CALIFORNIA COASTAL COMMISSION

December 21, 2000

**SUBJECT: STAFF RECOMMENDATION ON CITY OF SAN DIEGO MAJOR LOCAL
COASTAL PROGRAM AMENDMENT #4-2000 (CENTRE CITY—NORTH
EMBARCADERO OVERLAY DISTRICT)**

Proposed Waterfront District

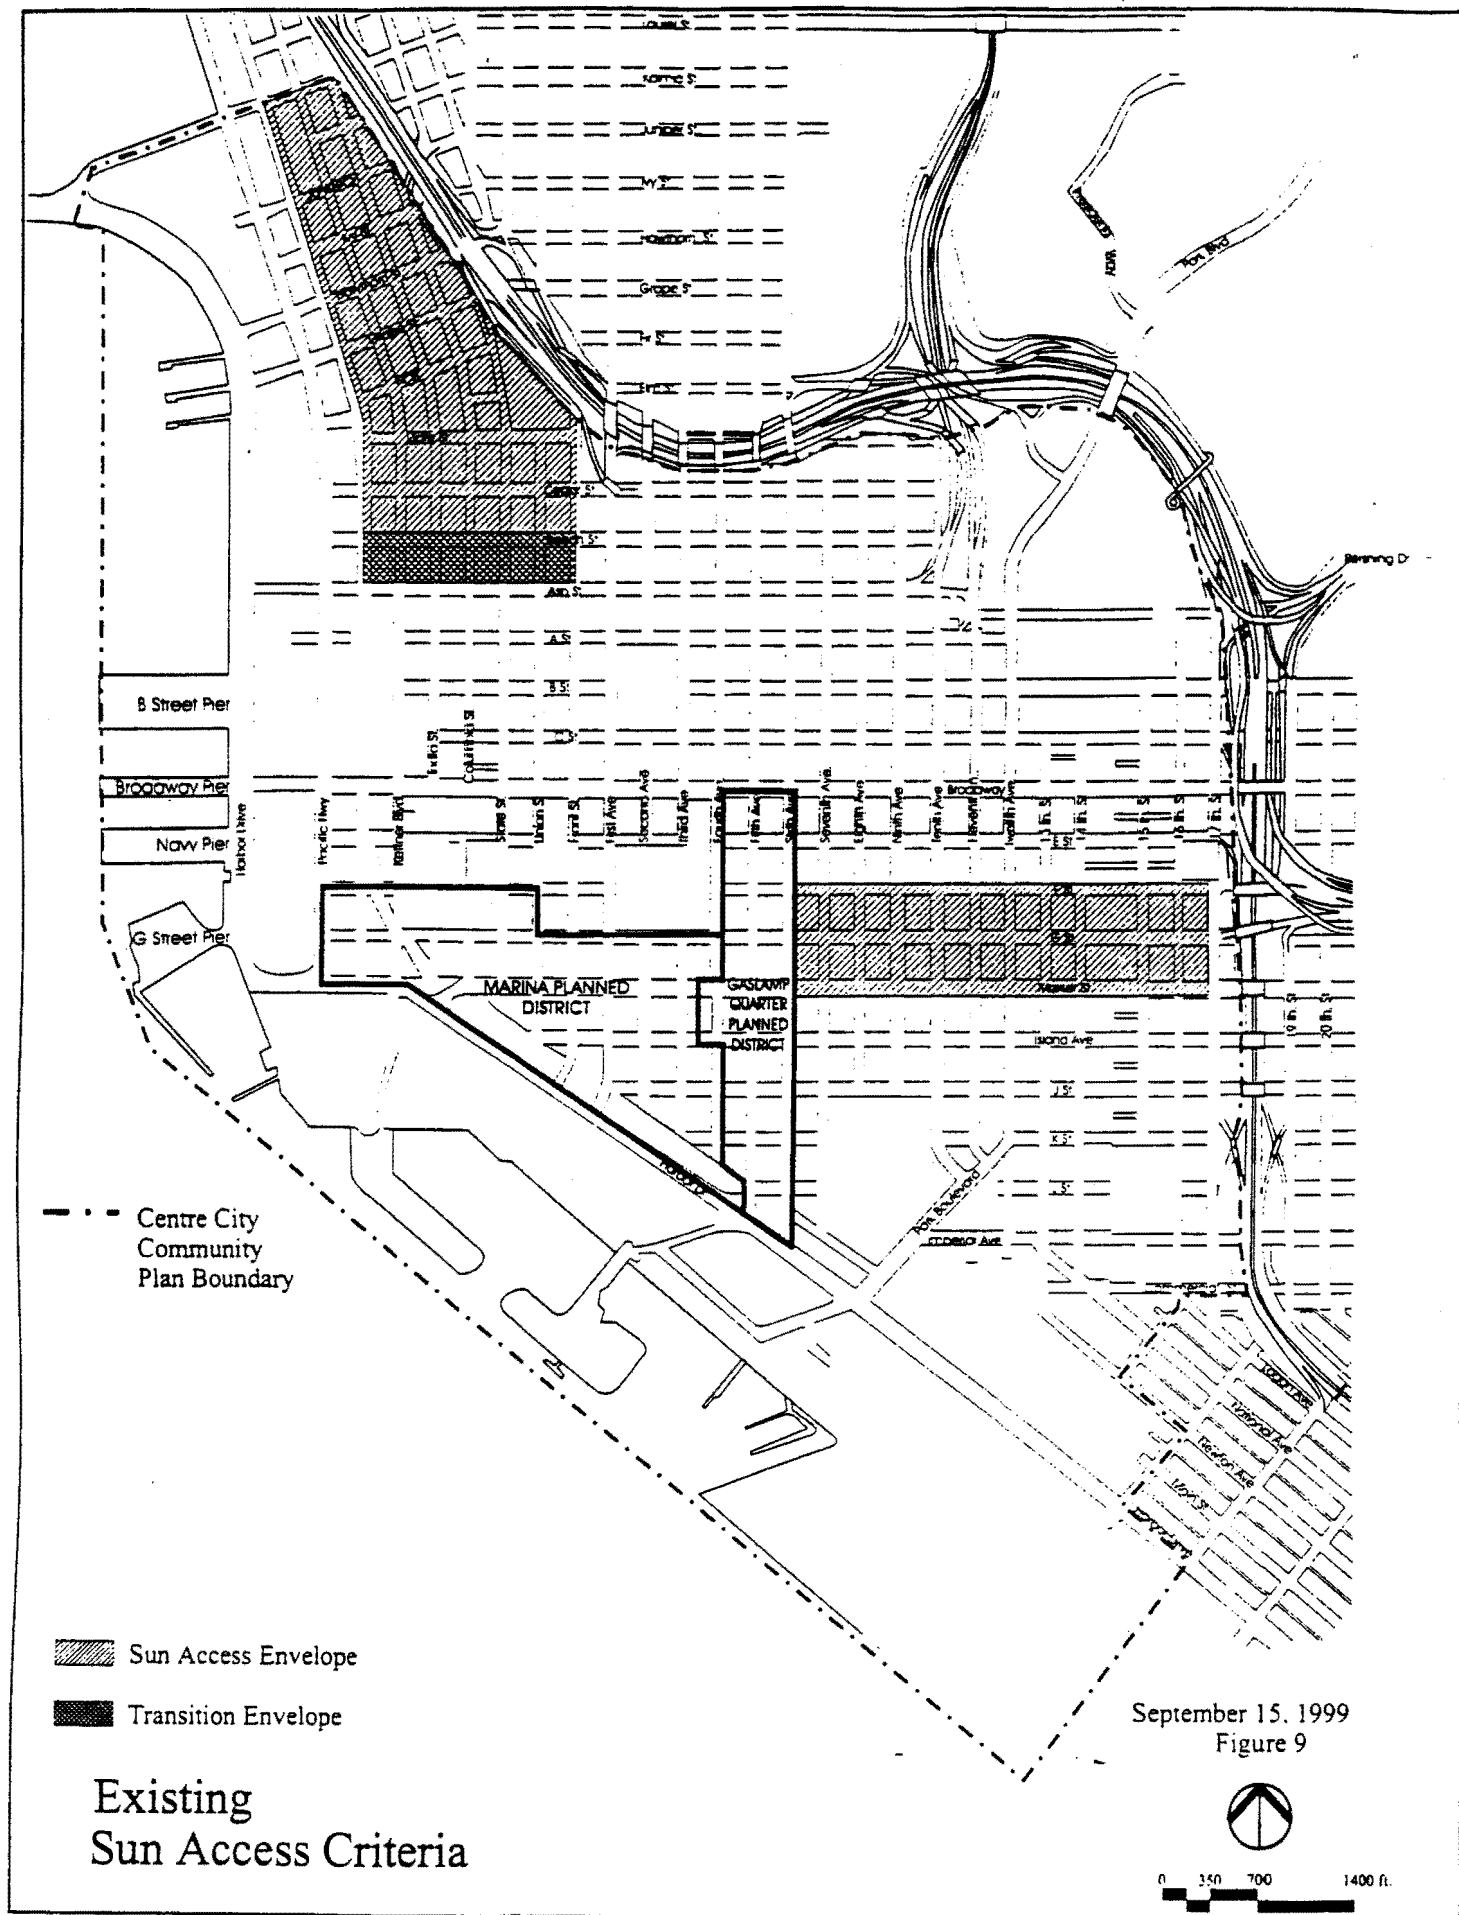
Suggested Modification #8 corrects a printing error on the proposed Figure 9, Waterfront District, to graphically depict both the existing Waterfront District and the proposed North Embarcadero Overlay District.

8. The proposed Figure 9, **Waterfront District**, shall be corrected to include a graphic depiction of both the Waterfront District, as shown on the existing Waterfront District figure, and the new North Embarcadero Overlay District (as proposed).
9. Table II of Section 103.1915 **VIEW CORRIDORS**, shall be revised as follows to increase the setback on C Street west of California:
